GM Recall 15822

Recall Bulletin

SUBJECT: Seatbelt Lap Anchor Tensioner Cable – Driver’s Side

MODELS: 2014-2015 Chevrolet Silverado 1500 Series
2014-2015 GMC Sierra 1500 Series

4551077

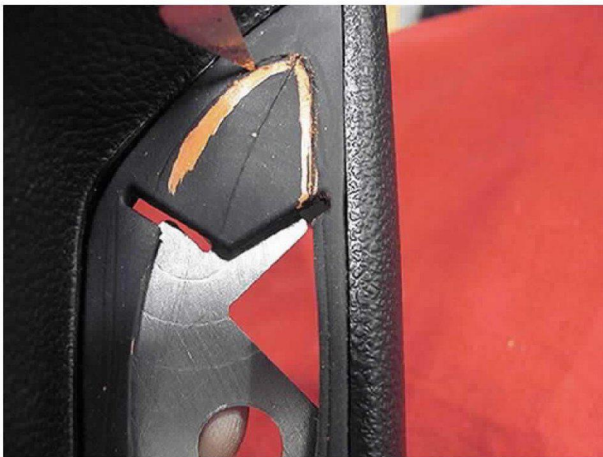
- f) Using a paint pen, mark the area of the rubber grommet to be removed.

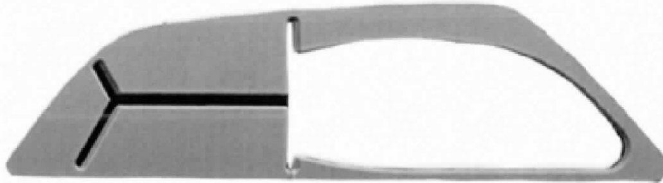
- g) Using a razor knife, cut the marked area of the grommet. A solid backing plate will help in creating an even cut. Use care to make a clean looking cut.
10. Complete the installation of the seat belt anchor plate tensioner cover, seat cushion outer finish cover and anchor plate to seat belt bolt assembly. Refer to *Front Seat Belt Anchor Plate Tensioner Replacement* in SI.
